REMEDIATION SYSTEM EVALUATION

MORGAN TERMINAL  
BROOKLYN, NEW YORK

Report of the Remediation System Evaluation,  
Site Visit Conducted at the Morgan Terminal Site  
June 4, 2003

**Remediation System Evaluation  
Morgan Terminal  
Brooklyn, New York**

**FIGURE 1-1. SITE MAP AND OBSERVED EXTENT OF FREE PRODUCT IN 2002.**

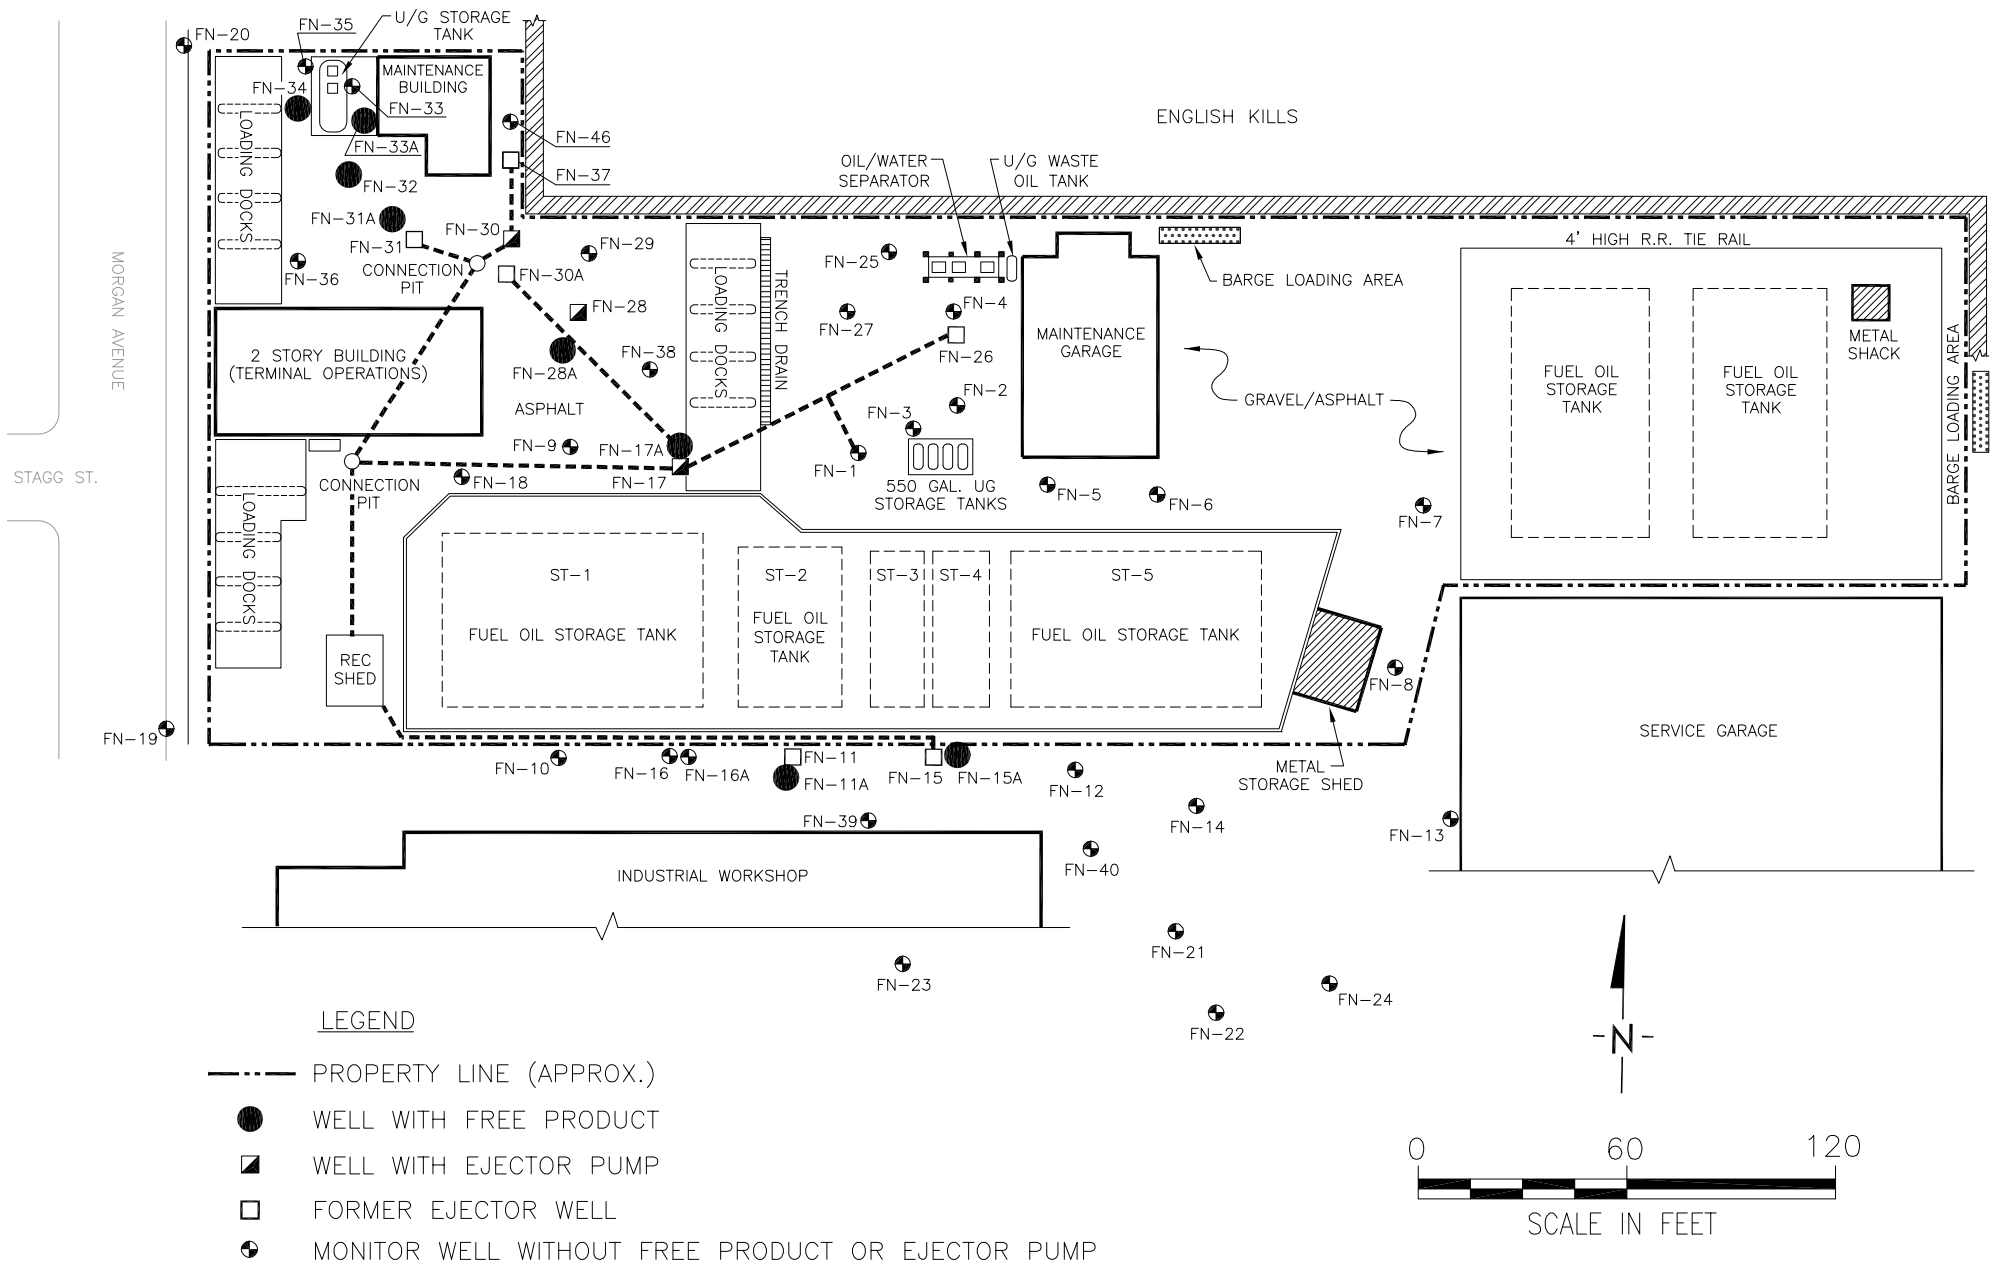
The fuel oil storage tanks and other operations were the likely sources of contamination. The following table outlines for each storage tank the construction material, capacity, and former contents. Other smaller underground storage tanks are also present on the site and are indicated on Figure 1-1.

Though some tanks have been removed and other tanks have been cleaned, the conditions beneath the large storage tanks (including ST-1 through ST-5 on Figure 1-1) have not been investigated and this area may have significant free product in the soil. The wells with the highest dissolved hydrocarbon concentrations (in the vicinity of FN-26) are not near the wells with free product as shown in Figures 1-1 and 1-2, but the remaining free product at the site may serve as a continuing source for other dissolved phase contamination. Analysis of the contents from some of the tanks in 1994 revealed chlorinated hydrocarbons (tetrachloroethene, 1,1,1-tetrachloroethane, and trichloroethene) at the mg/L level. As of the RSE site visit, ground water samples had not been analyzed for these constituents.

Contaminants of concern include both free product and dissolved phase contamination. Figure 1-1 depicts the site monitoring wells and indicates those where free product has recently been observed. Figure 1-2 depicts the extent of MTBE and BTEX (benzene, toluene, ethylbenzene, and xylene) dissolved phase contamination. Although the extent of free product is smaller than it historically has been, the remaining free product is generally No. 6 fuel oil, which has been difficult to remove through either extraction or in-situ degradation.

In addition to improving the site aesthetically and improving the probability of development, removal of the derelict equipment and structures will allow investigation and remediation of the site to proceed unimpeded. The site tanks (including retaining/containment walls and mounded soil), structures, pipes, and loading racks should be removed. The concrete and steel could be disposed in a C&D landfill or recycled. Some cleaning would be necessary to remove oil staining. Based on a review of the site map, the footprint of all structures on the property is as follows:

**FIGURE 1-2. EXTENT OF DISSOLVED CONTAMINATION ABOVE THE MOST STRINGENT STATE STANDARDS AS OBSERVED IN JULY 2002.**

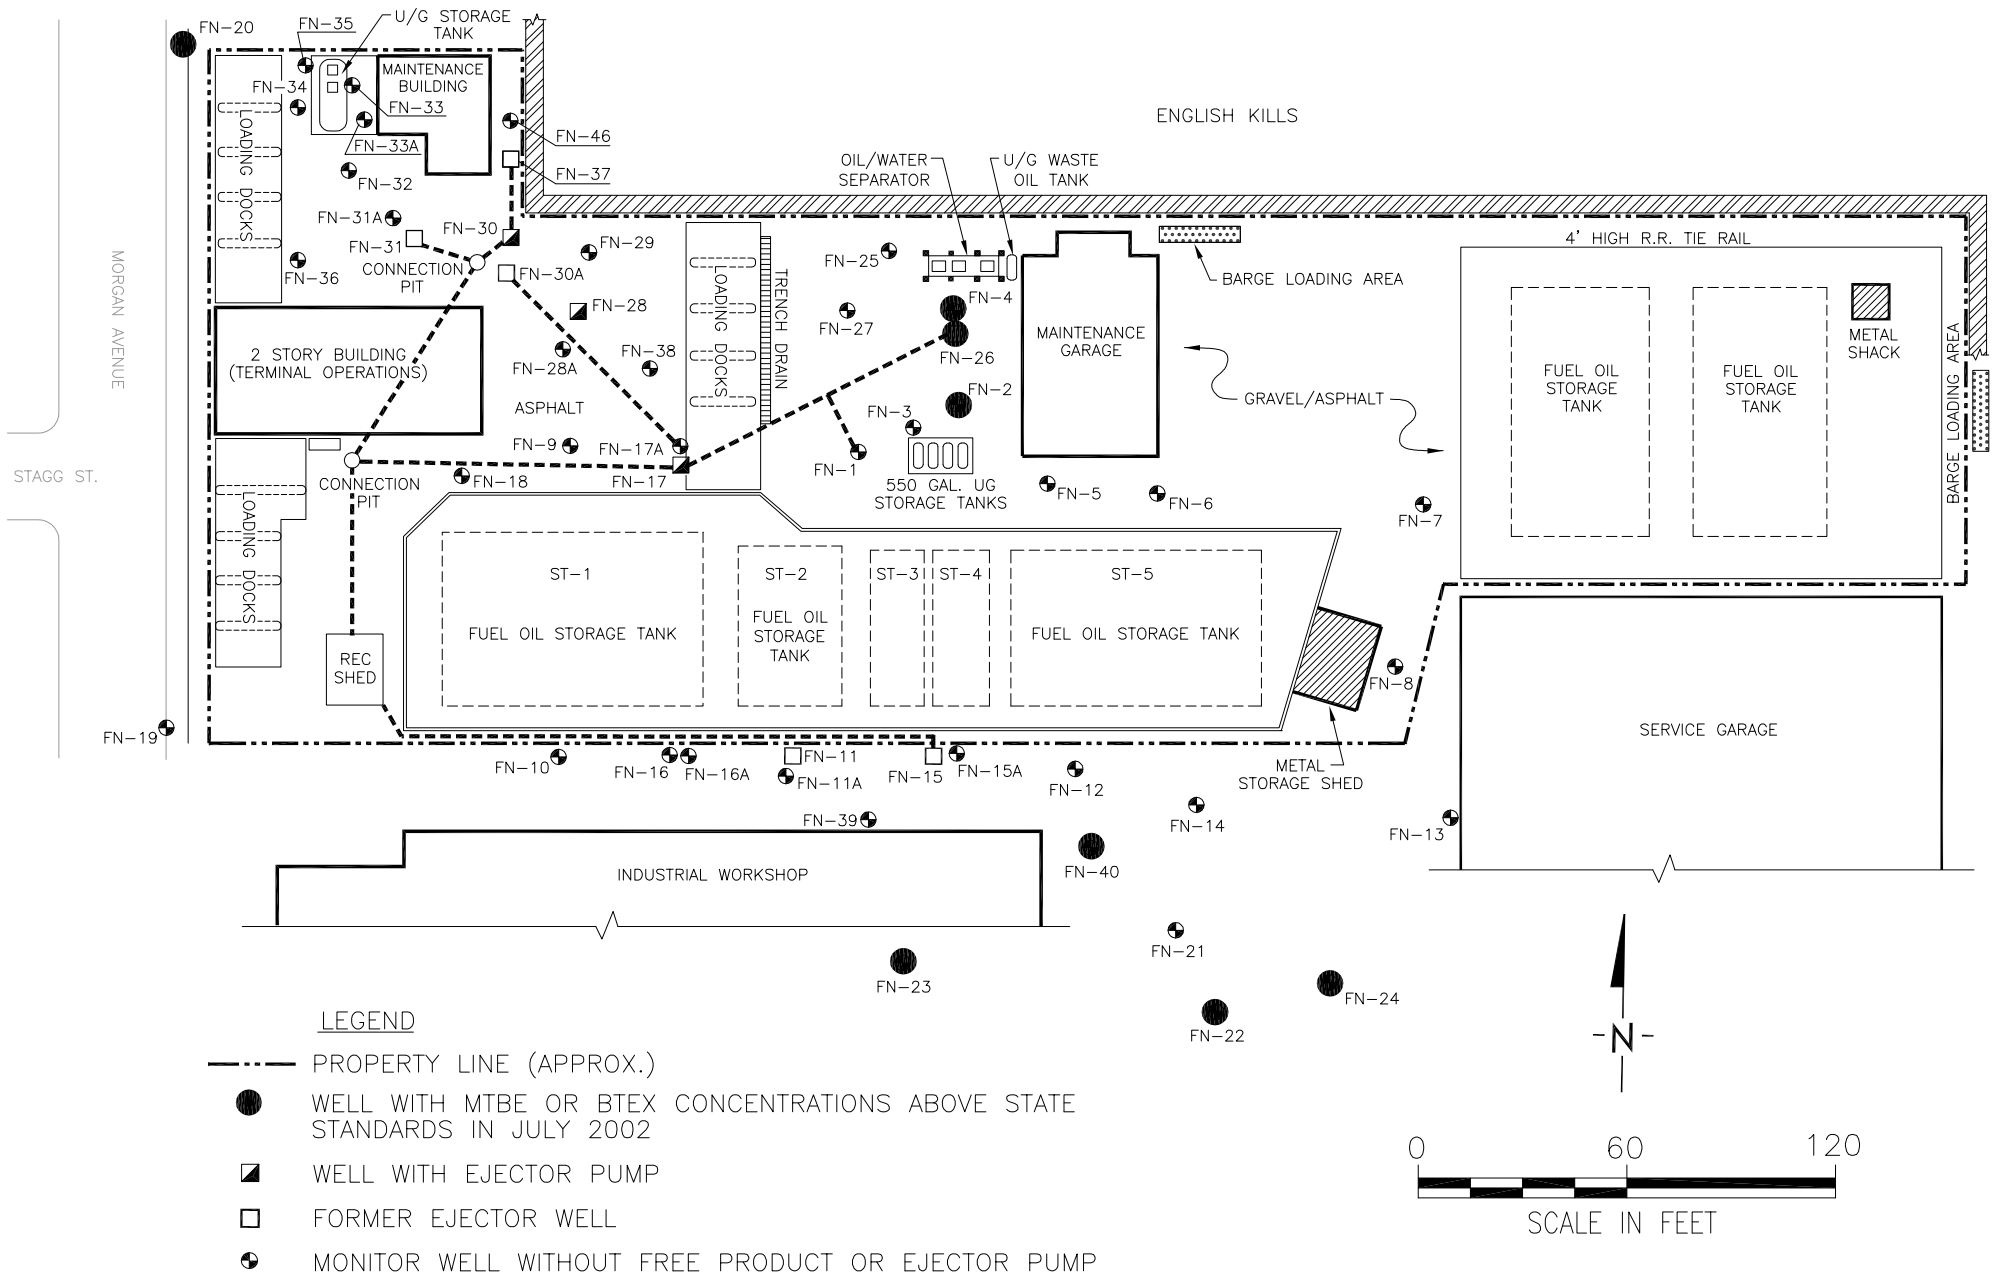
Ground water flow is generally to the northwest toward the English Kills at an approximate hydraulic gradient of 0.01 feet/foot. Ground water flow, however, is substantially influenced by mounding near the storage tanks. As a result, ground water near the southern boundary of the property flows off site to the south. MTBE contamination has been found over 50 feet to the south of the site (FN-22 as depicted in Figure 1-2).
